Change Number	Federal Facility Agreement and Consent Order Change Control Form Do not use blue ink. Type or print using black ink.	Date
M-45-10-2		6/28/10

RFI/CMS Work Plan Primary Document Schedule Modification.

Phase 2 RCRA Facility Investigation/Corrective Measures Study Work Plan for Waste Management Area C,
RPP-PLAN-39114,
Revision 1A (Changed Pages)

SAMPLING AND ANALYSIS PLAN FOR PHASE 2 CHARACTERIZATION OF VADOSE ZONE SOIL IN WASTE MANAGEMENT AREA C

Figure 6-1. Project Logic and Schedule ~~(2 sheets)~~

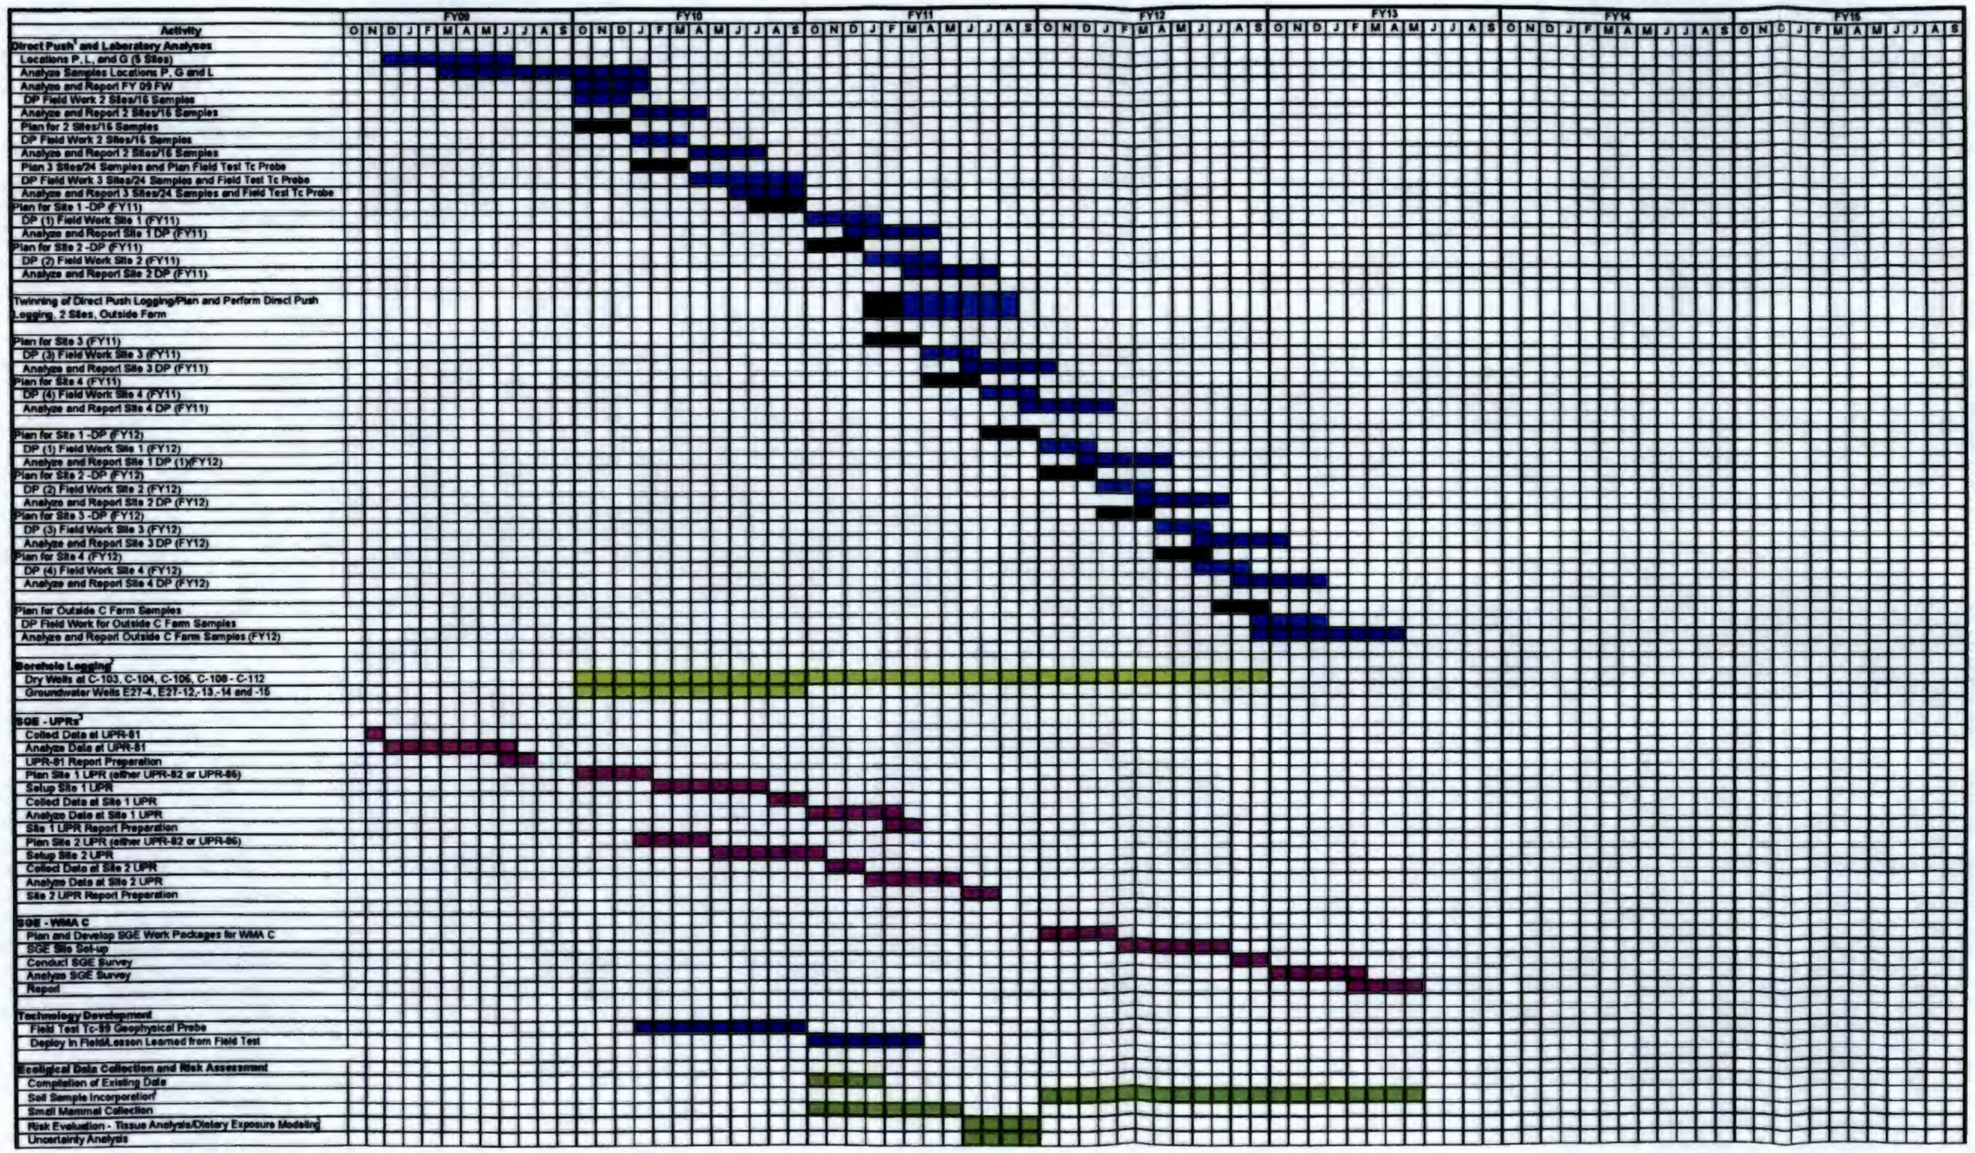
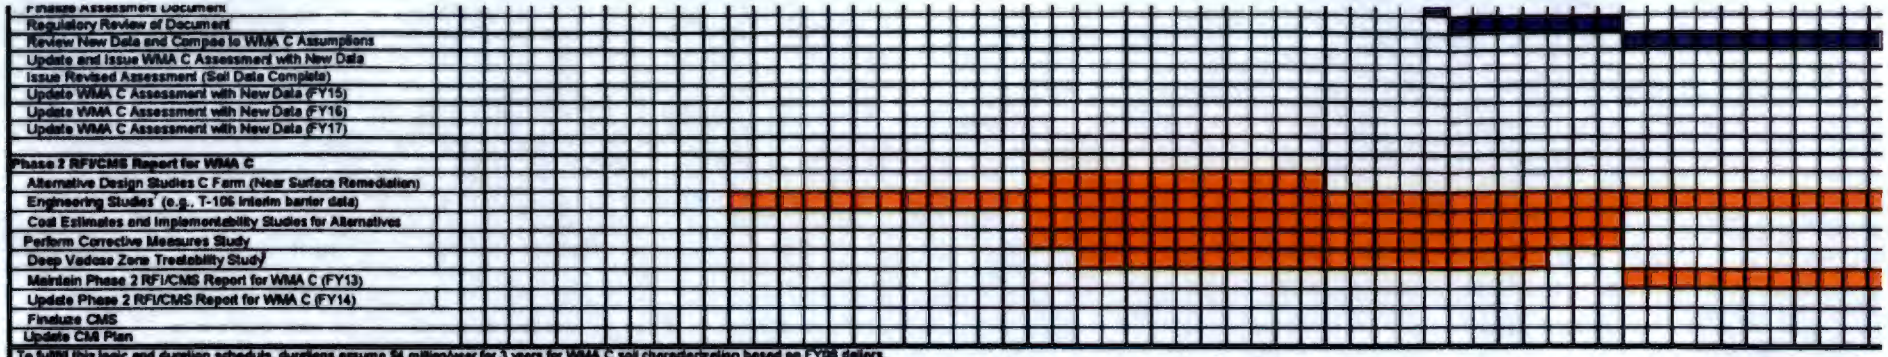
To fulfill this logic and duration schedule, durations assume $4 million/year for 3 years for WMA C soil characterization based on FY08 dollars.

Durations for activities assume no interferences from field activities, such as waste retrieval activities, which are currently ongoing.
